City of Kodiak
Kodiak Police Department Security Controls Upgrade PN 22-07/4068
Addendum No. 2
June 13, 2022

The following change(s) and/or clarification(s) are made to the Plan and Specification Documents of Request for Proposals (RFP) for the Kodiak Police Department Security Controls Upgrade PN 22-07/4068:

RFP DOCUMENTS 4-29-2022

SHEET:
E1.2

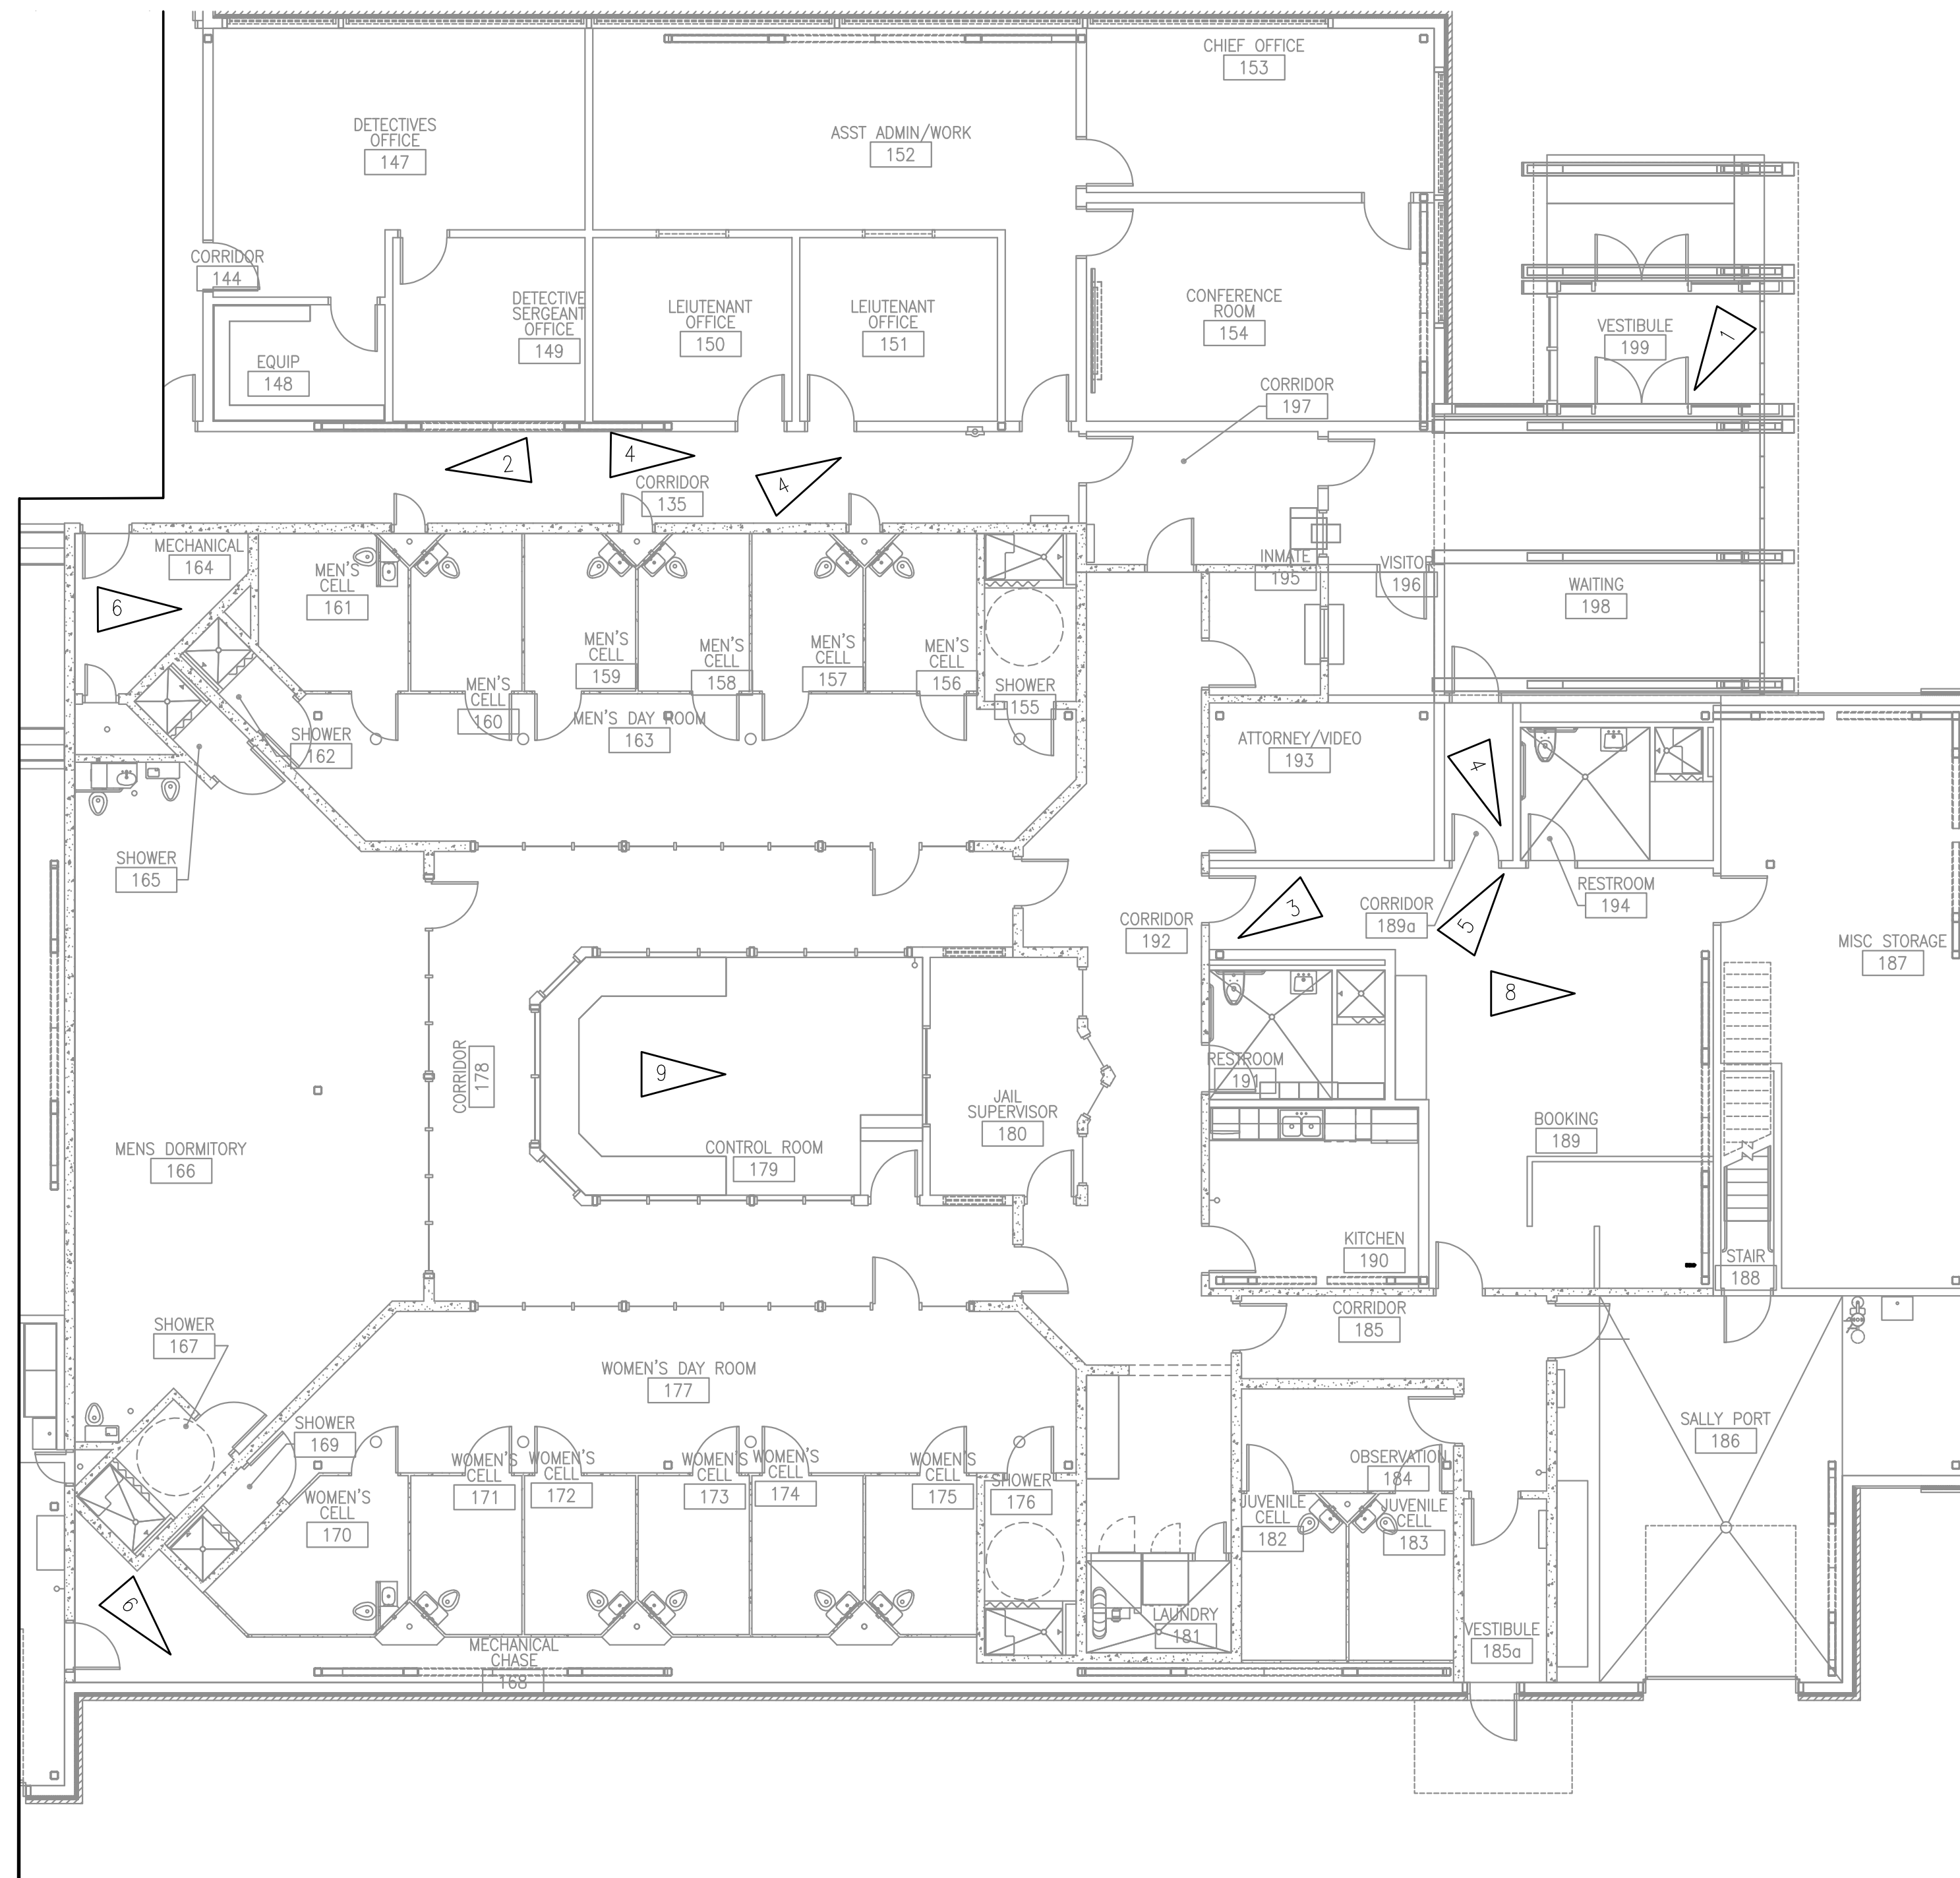
5	Are there any changes to the security groups that are desired and not specified?	See above for groups to provide
6	Sheet note D of E1.1 suggests that the cabling for the access control system can be re-used. During the pre-bid conference it was discussed that the cabling is to be replaced. Confirm the scope of work specific to the card access cabling.	See Electrical Performance Specifications dated 4-29-22 which replace 3-9-22 set. Sheet Note D of E1.1 says that access control system scope of work shall include replacement of cabling.
7	Sheet note 7 on E1.2 suggests there is a failed camera on the East Side of the facility, but there's no sheet note callout shown on the floor plan. Confirm this camera location is one that is identified by sequence number from the as-builts to be part of the base bid, and not an alternate bid camera that needs to be included in the base bid.	The camera that is not working is #39 shown on SE-1.1 of the 1050812 Kodiak Police As-Builts, and is located at door 185b (the inner door of Vestibule 185a, plan southeast on Sheet E1.2 of Electrical Performance Specifications)
